Planning, Land Use and Mobility Committee
Case Report / Rev 7.16.20; Rev 8.6.20
DIR-2019-4861-DRB-SPP-MSP / Single Family Residence
22552 W. Uhea Road
Woodland Hills, CA 91364

Project Description: New Single Family Residence
Applicant: Javanshir Rad t: 213.361.6555; e: danny@radtronics.com;
Representative: Behrouz Bozorgnia/Mobbil Inc; t: 310.562.6427; e: bbozorgnia@mobbil.com
LA City Planner: Valentina Knox-Jones: 818.374.5038; valentina.knox.jones@lacity.org
Case Leader: Lauren Coffman / PLUM Chair / l.coffman@whcouncil.org
PLUM Meeting: January 9, 2020 / First Presentation
July 16, 2020 / Second review by PLUM Committee only
August 6, 2020 / Third Review

Previous Exterior

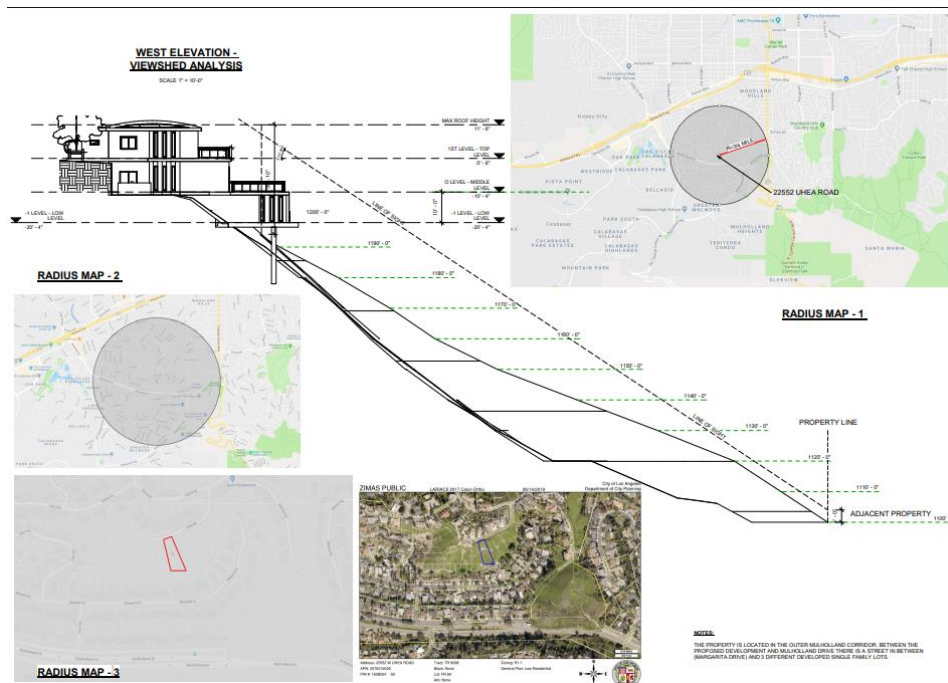
The exterior colors are white and grey, which will not blend with the hillside. The exterior color will have to be modified to conform with the DRB standards.

8.6.20: The colors have been revised to conform with Mulholland scenic Parkway suggested building color palette.

Grading:

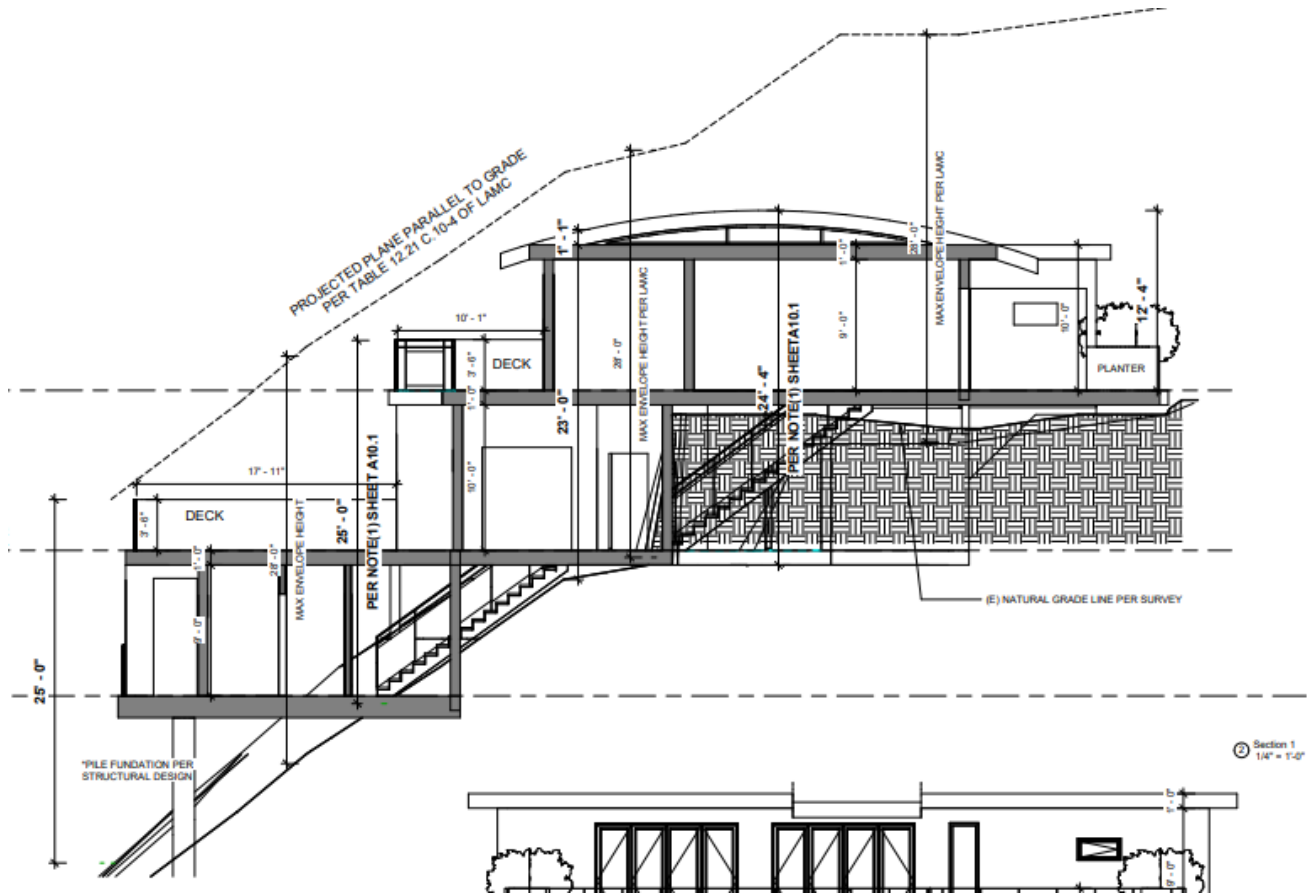
The project requires 1,100.1 cubic yards of cut and 9.08 cubic yards of fill for a total export of 1,091.03 cubic yards for grading. **Maximum allowable, as per the Hillside Ordinance is 1,000 cubic yards. Lots fronting on Substandard streets are limited to 750 cubic yards of cumulative grading.** The project proposes to work with the average natural slope of 35%. There are no trees proposed to be cut down.

Original Planting Plan

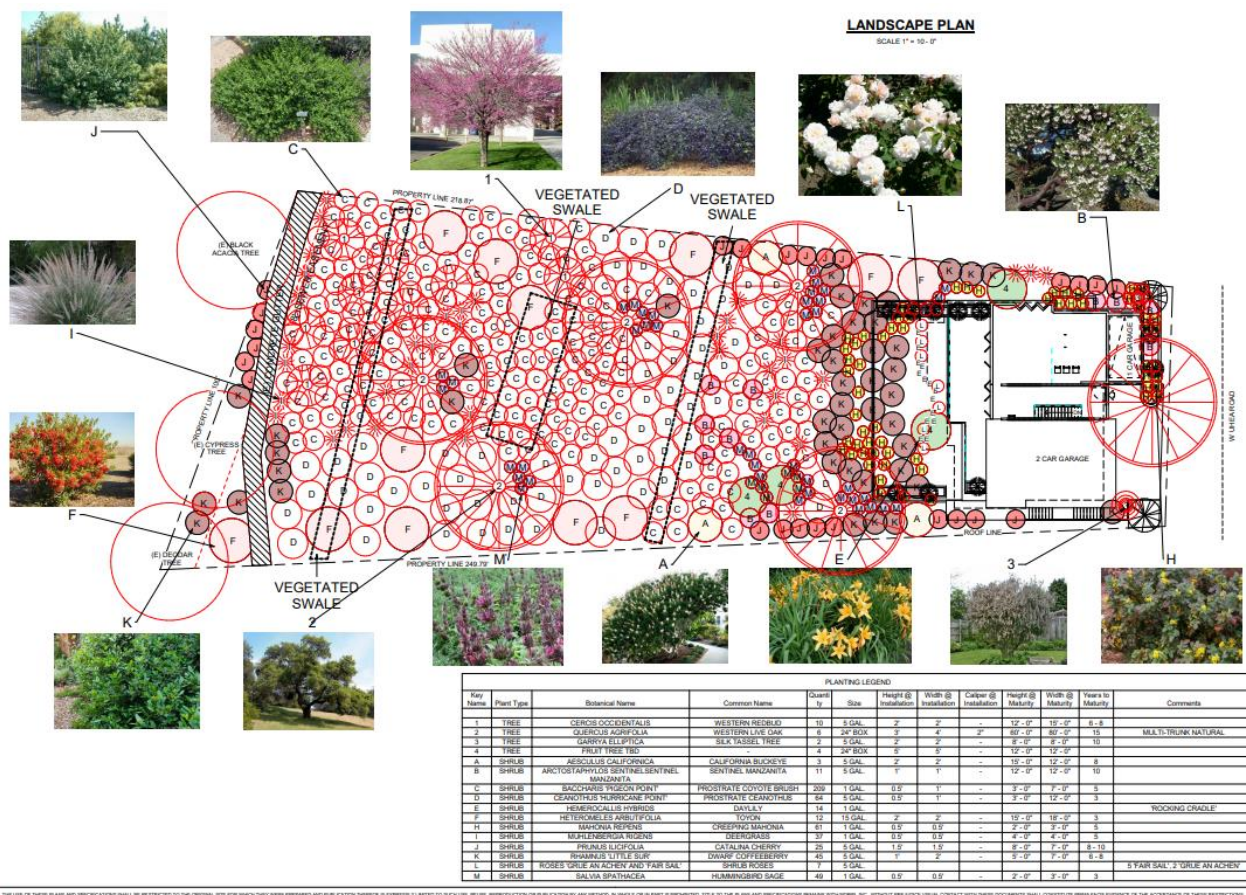
5. Drainage not addressed: Where is all the roof drainage going? What is the project system for Storm water Infiltration? Applicant should consider terracing the site to slow down rain water flow to neighborhood below. See Page 10 this report / Revised Planting Plan. As per Guidelines For Storm Water Infiltration, it is very possible that planter boxes will not be allowed on elevated platforms, decks or porches. Consult the building code officials.

8.6.20 / Revised Planting Plan with Vegetated Swales In response to PLUM's request for better management of storm water site drainage site terracing and more controlled storm water drainage, the applicant has introduced vegetated swales to slow the storm water flow, as demonstrated on revised sheet A11 / Landscape Plan. I think these swales need to be wider, more like terraces, to be effective. The Natural Drainage Pattern existing allows only for sheet flow, which creates water flow too fast to irrigate new planting.

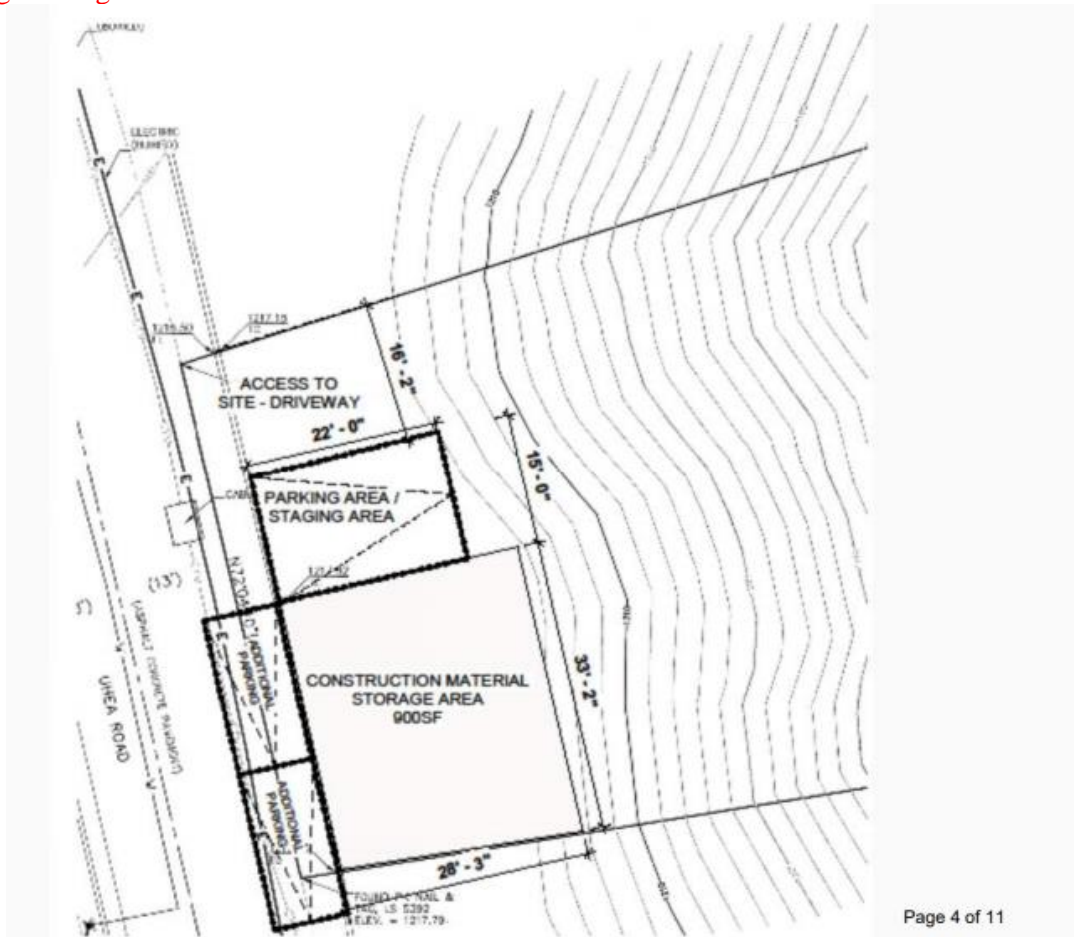
The applicant will provide a Staging Area Plan for construction materials receiving and storage, as part of the submittal set, for WHWCNC Board review. **Staging/Parking Plan added 8.6.20**

4. The applicant will provide a Parking Plan for contractors and construction workers, as part of the submittal set, for WHWCNC Board review.

Staging/Parking Plan added 8.6.20

Maximum Building Envelope Study

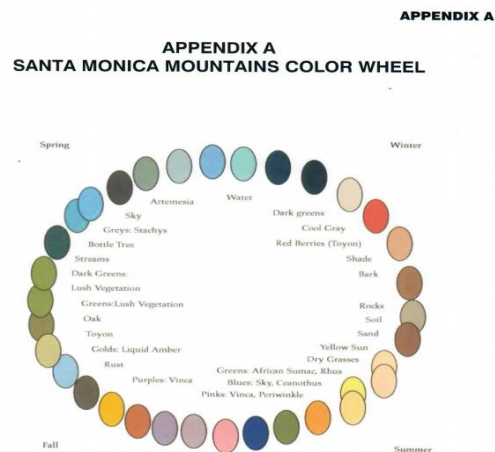
2. Building envelope height still does not conform. Maximum Envelope Height “ Envelope height (otherwise known as vertical height or “plumb line” height) shall be the vertical distance from the Grade of the site to a projected plane at the roof structure or parapet wall located directly above and parallel to the Grade. Measurement of the envelope height shall originate at the lowest Grade within 5 horizontal feet of the exterior walls of a Building or Structure.” 12.21.C.10.(d)(1) of the LAMC

8.6.20: On sheet A10 and A10.1, the applicant demonstrates the maximum envelope height correctly: 28’ is allowed for flat roof structures, and the project has an envelope height of 25. The maximum envelope height is taken from the lowest grade, which is at the base of the caissons, where they enter the earth.
